UNITED STATES ENVIRONMENTAL PROTECTION AGENCY
WASHINGTON, D.C. 20460

August 29, 2013

Dear ENERGY STAR® Set-top Box Partners and Other Interested Parties:

In response to feedback on Draft 2 of the ENERGY STAR 4.1 Set-top Box specification and the dataset used to develop it, the Environmental Protection Agency (EPA) is seeking further input on a number of contemplated changes, prior to the publication of a Final Draft.

Figure 1: Total and Base Energy Consumption for Cable, Satellite, and MVPD IP Models Certified to Version 3.0, Compared to the Proposed Version 4.1 Base Allowances¹

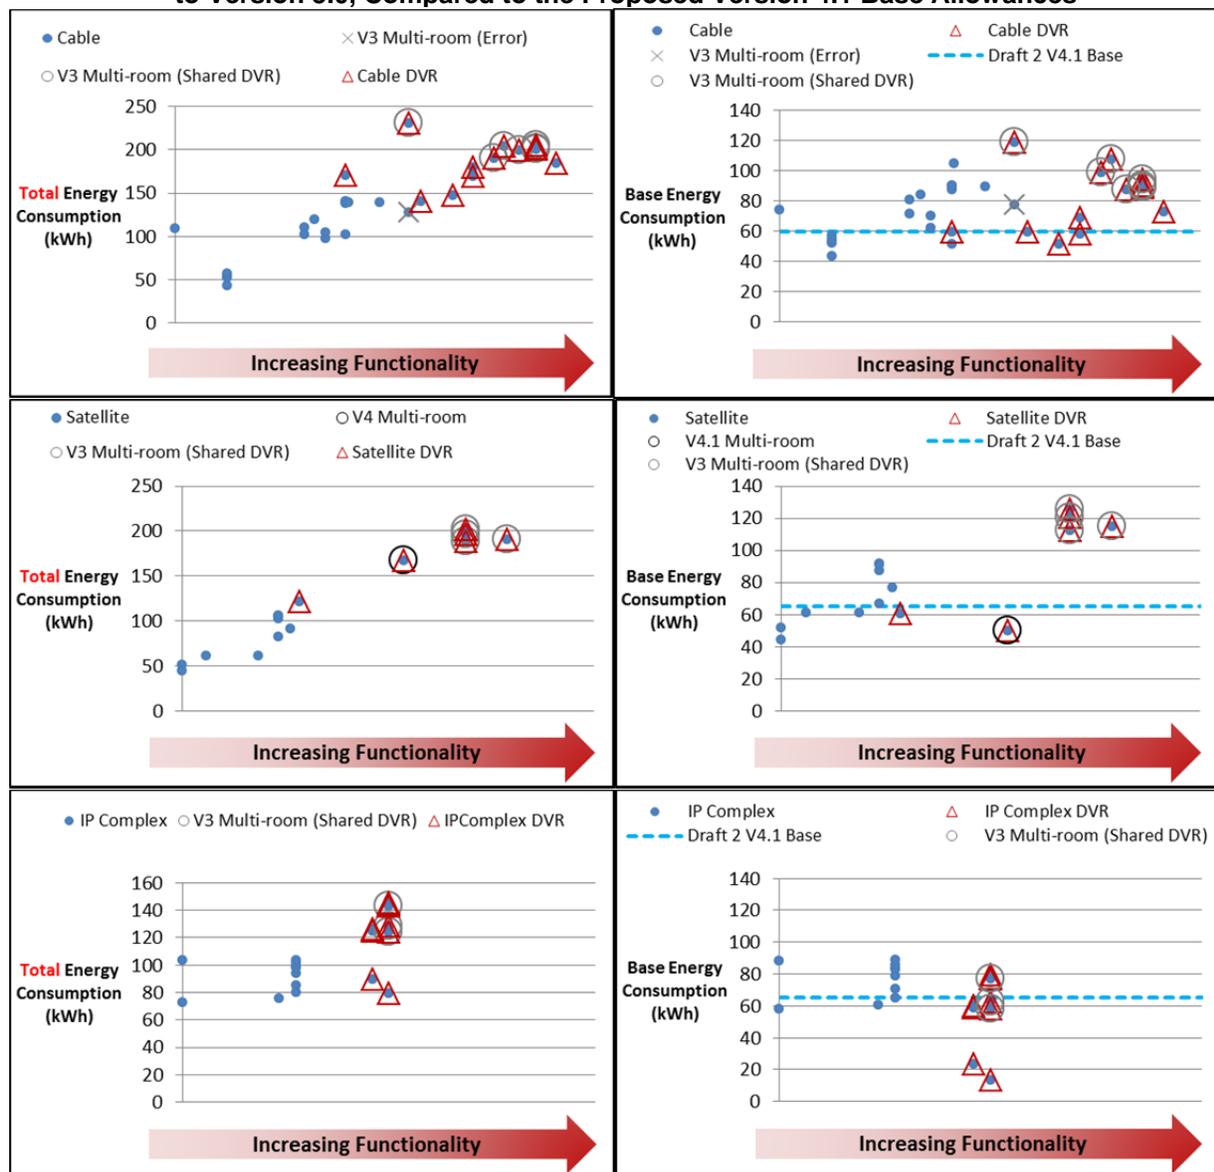
In consideration of the updates to EPA's dataset and additional functionality allowances as outlined above, EPA reevaluated previously proposed base levels, ensuring that a selection of STBs of each base type could meet the proposed levels. The allowances under consideration are listed below in Table 3 with changes shown in yellow, with the most significant changes being the increases in the allowance for

Thin Client and Service Provider IP base types. In Attachment 1 at the end of this memo, EPA depicts the data used to determine base levels.

The Figure 1 graphs below plot the data used to develop proposed levels for Cable, Satellite and MVPD IP (labeled “IP Complex”) base types. For each of these base types, the total estimated Annual Energy Consumption (AEC) are plotted in the left graph. These data were derived by crosswalking the Version 3 qualified data to the AEC used in Version 4.1. Individual STB models are displayed along the x-axis according to increasing functionality (i.e. # of applicable Additional Functionality Allowances). The right graph shows the proportion of estimated AEC allocated to base type energy consumption, by subtracting all applicable Additional Functionality Allowances from the total AEC. Distribution of models along the range of functionality indicates effectiveness of Additional Functionality Allowances to recognize a variety of efficient models.

Models below the blue dashed line are estimated to meet the levels proposed in this memo.

BASE FUNCTIONALITY	ES V4.1 Updated (kWh/yr)
Cable Digital Transport Adapter (DTA)	40
Cable	60
Satellite	65
MVPD IP	65
Over-the-top IP	10
Terrestrial	18
Thin Client	30
